Item Name: Crosstube Turning Detail

DART AEROSPACE LTD	Work Order:	95465
Description: Crosstube Assembly (412 Low Aft)	Part Number:	D412-664-249
Inspection Dwg: D412-664-249 Rev: B		Page 1 of 2

DRAWING NO. D412-664-249	TITLE CROSSTUBE ASS'Y (412 LOW AFT)	REV. B	DART AEROSPACE LTD ENGINEERING ORDER		D.E.O. NO. D412-664-249-B-1	SHEET NO. SHEET 1 OF 2	SCALE NTS
DRAWN <i>q</i>	CHECKED <i>Sc</i>	MFG. APPR. <i>R</i>	APPROVED <i>MD</i>		DE APPR. <i>MD</i>		
DATE 11.05.25	DATE 11.05.31	DATE 11.05.31	DATE 11/05/31		DATE 11.05.31

REMOVED ABRASION STRIP IN FAVOR OF A THIN LAYER OF PROSEAL 890. UPDATE INSTALLATION OF CHAFING SHIELDS AND REDUCE TORQUE TO 40-50 IN-LBS. THIS ENGINEERING ORDER SUPERCEDES DEO D412-664-249-B-1

D412-664-249
ASSEMBLY DETAIL

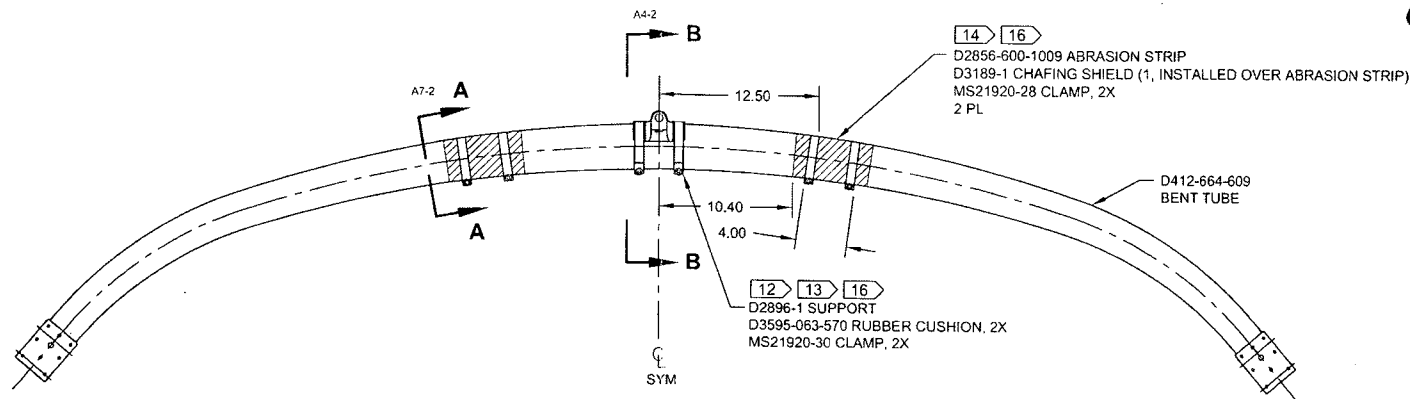
REMOVED ABRASION STRIP IN FAVOR OF A THIN LAYER OF PROSEAL 890.

D2856-600-1009 ABRASION STRIP
D3189-1 CHAFING SHIELD (1, INSTALLED OVER ABRASION STRIP)
MS21920-28 CLAMP, 2X
2 PL

D3189-1 CHAFING SHIELD (1, INSTALLED OVER PROSEAL 890)
MS21920-28 CLAMP, 2X
2 PL

D412-664-249
ASSEMBLY DETAIL

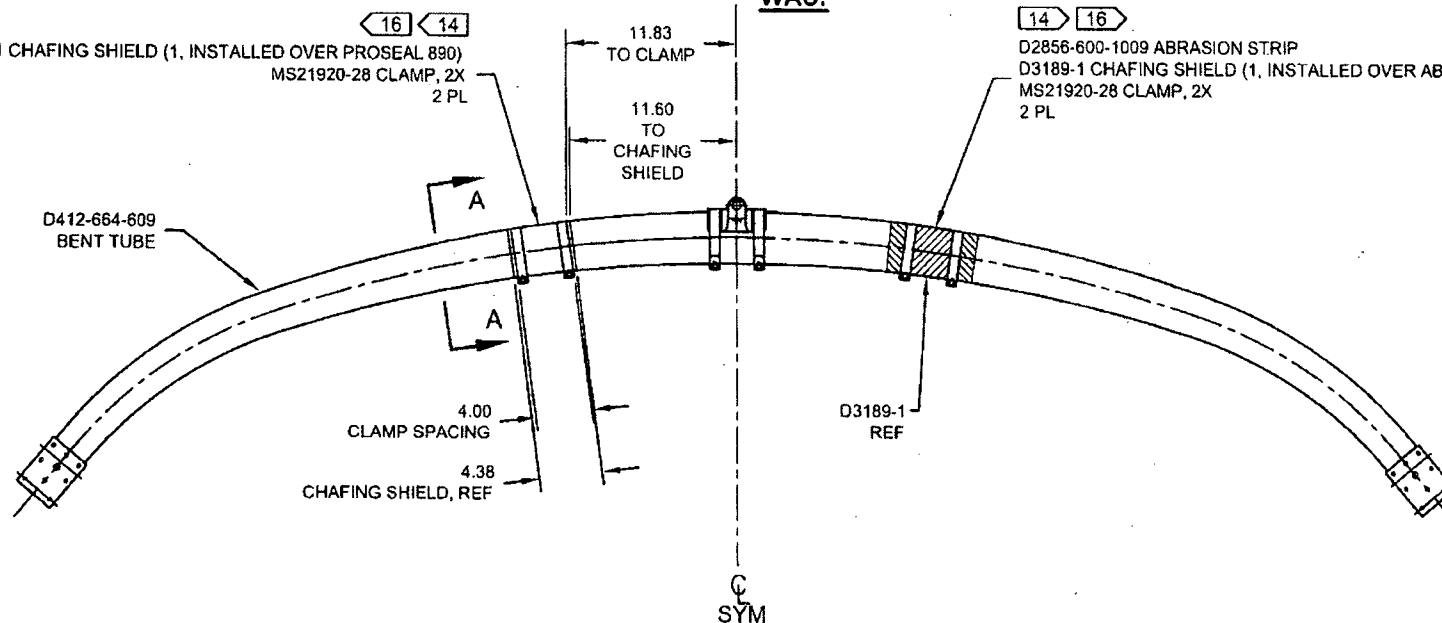
WAS:

D2856-600-1009 ABRASION STRIP
D3189-1 CHAFING SHIELD (1, INSTALLED OVER ABRASION STRIP)
MS21920-28 CLAMP, 2X
2 PL

IS:

D3189-1 CHAFING SHIELD (1, INSTALLED OVER PROSEAL 890)
MS21920-28 CLAMP, 2X
2 PL
